SERVICE BULLETIN 9B

SUBJECT: Nose Gear Shimmy

APPLICATION: All Glasair RG aircraft.

FIGURE (1)

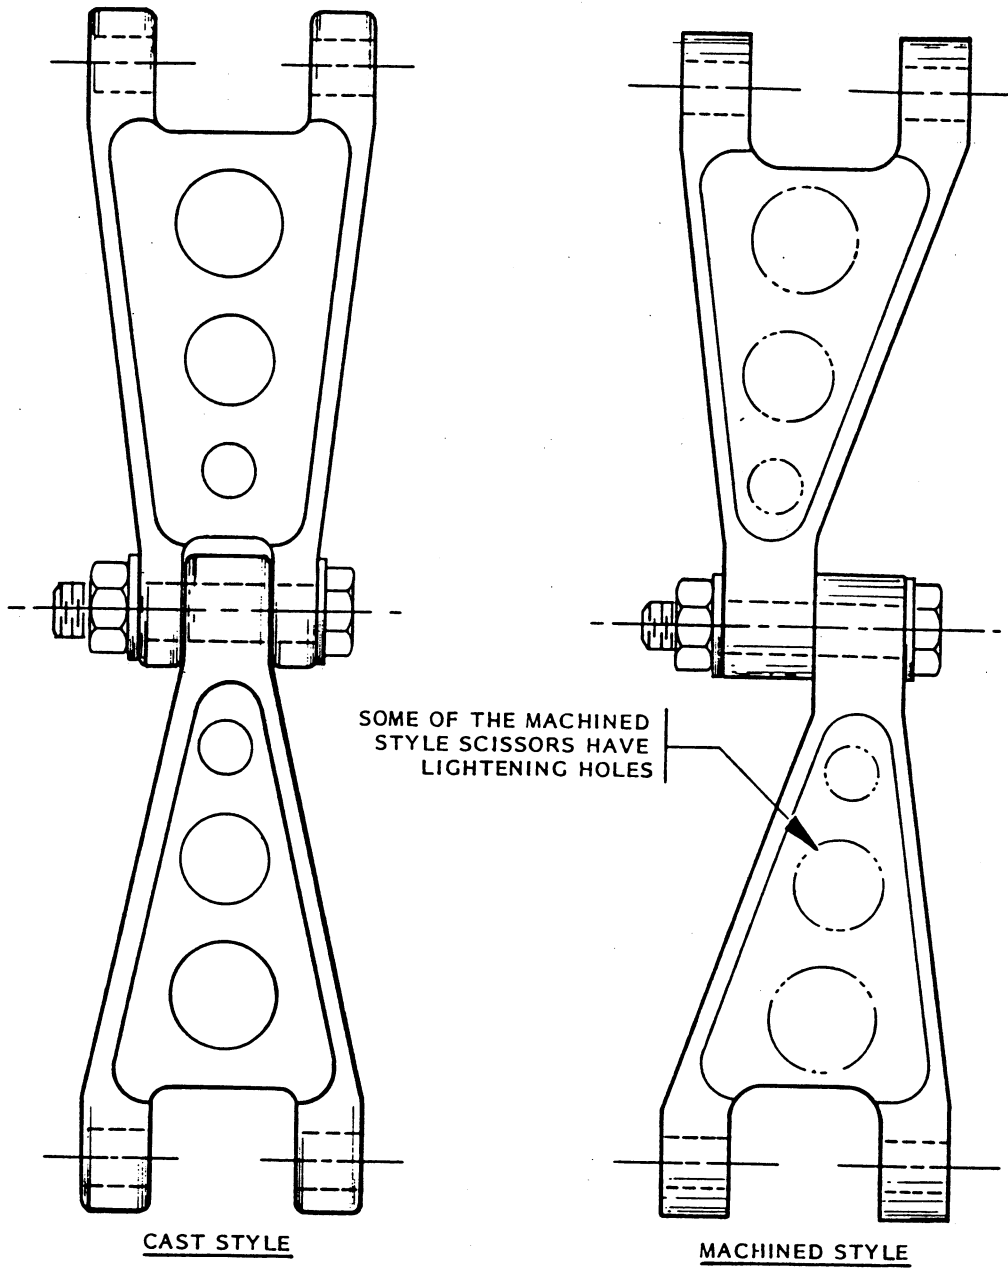
Another possible source of play in the nose gear assembly is the Nyliner bushings used in the scissors pivot joints. If you are continuing to experience nose gear shimmy, and you have eliminated all the other potential causes discussed in Service Bulletin 9, you may want to consider replacing the Nyliner bushings in your nose gear scissors with aluminum bronze bushings.

On our 180 hp RG model, N84AG, we replaced the Nyliner bushings in the nose gear scissors with aluminum bronze bushings and noticed less play in the pivot joints. It is still inconclusive whether this procedure is necessary to help eliminate shimmy, but we mention it in case someone else with shimmy problems wishes to try it. We used NAS76A bushings and cut them to the proper lengths.

Two types of scissors have been used on Glasair RGs, as illustrated in FIGURE (1). An aluminum insert was used with some of the machined style scissors, allowing the aluminum bronze bushings to be pressed into place without any drilling or reaming.

To press the aluminum bronze bushings into place, the scissors must first be drilled and reamed to accommodate the larger outside diameter of the bushings.

CAUTION: It is very critical when drilling and reaming the scissors for the larger bronze bushings that proper alignment is maintained and the scissor lugs are not flexed. A drill fixture should be made to hold the scissors and a specially ground pilot ream should be used. It is very likely that the scissors could be ruined if these holes are not properly drilled.

FIGURE (2)

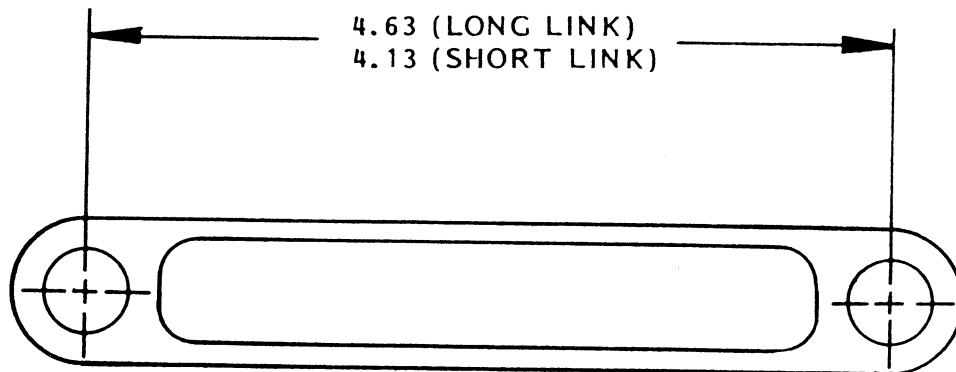
The installation of a longer drag link may have had the effect of reducing nose gear shimmy on one Glasair RG with which we experimented. The longer drag link was standard equipment in the first 70 sets of RG landing gear but we went to a shorter link on later gear to make the airplane easier to steer. The effect of the longer link when the gear is extended is to angle the strut out farther toward the front slightly, increasing the amount of caster which may tend to stabilize the nose wheel.

To determine if you have the longer or shorter drag link, measure between the centers of the two drag link pivot bolts, as shown in FIGURE (2). The short link is 4.13 in. between pivot centers; the longer link is 4.63 in. between centers, as shown.

FIGURE (3)

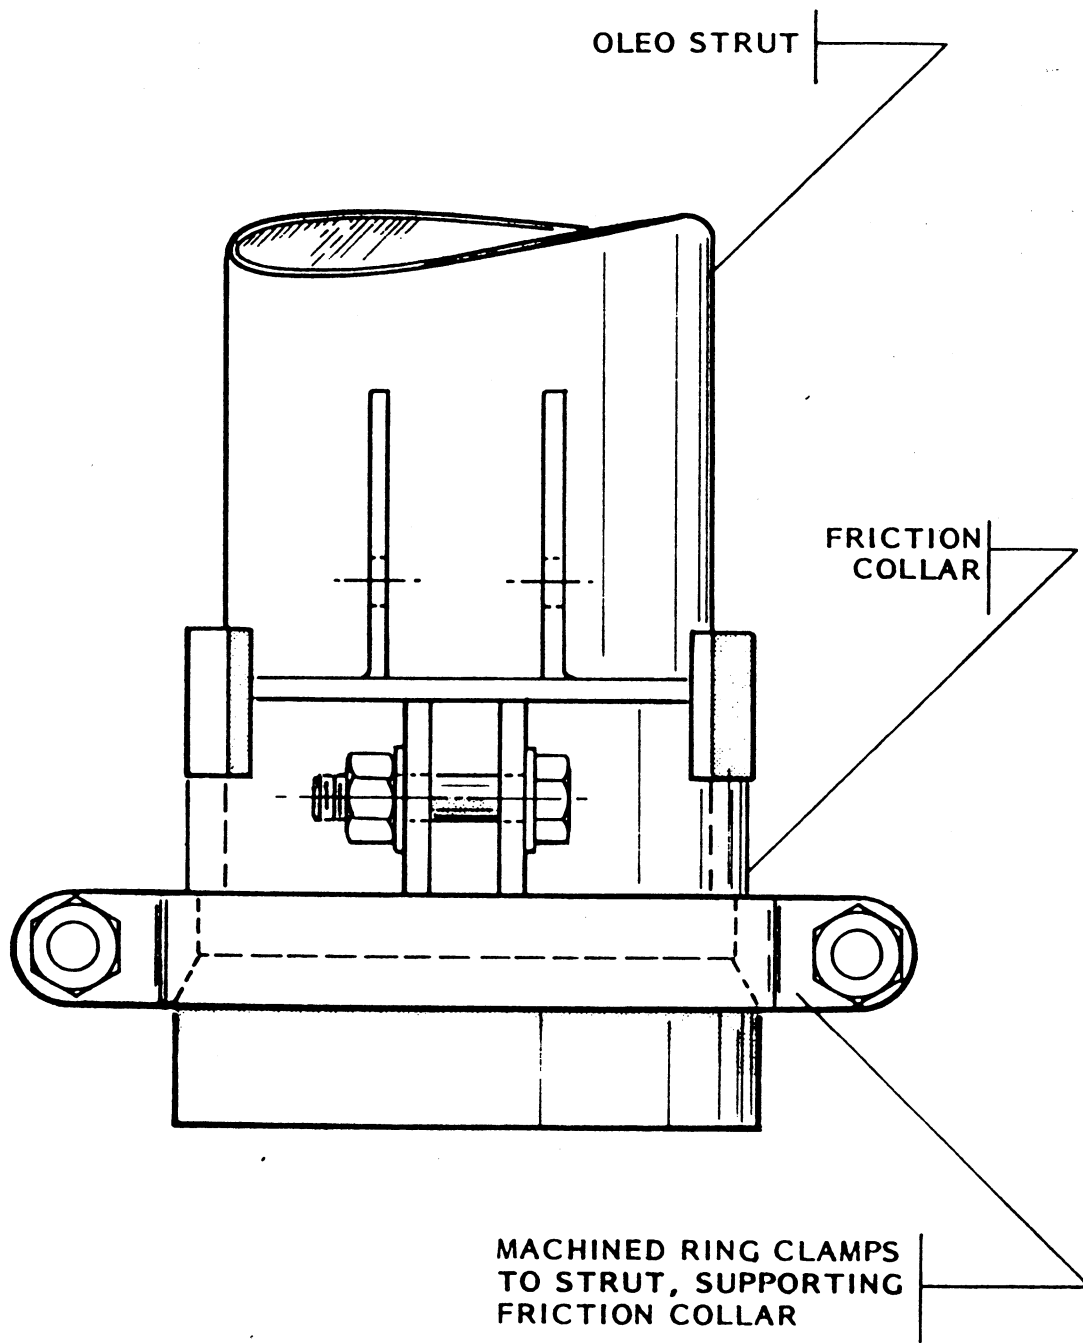
Another area of possible contribution to shimmy is "racking" of the friction collar clamps. The lower edge of the friction collar is chamfered to clear the cylinder/gland weld which allows the collar to rack slightly when load is applied. Ideally, the collar needs to be captured snugly in a recess.

A possible method of stabilizing the friction collars is a lower clamping ring for the nose gear oleo strut. This ring would clamp around the strut just below the friction collar recess and would provide a surface for the collars to bear against, preventing the collars from racking under load. See FIGURE (3) for a clarification of this concept.
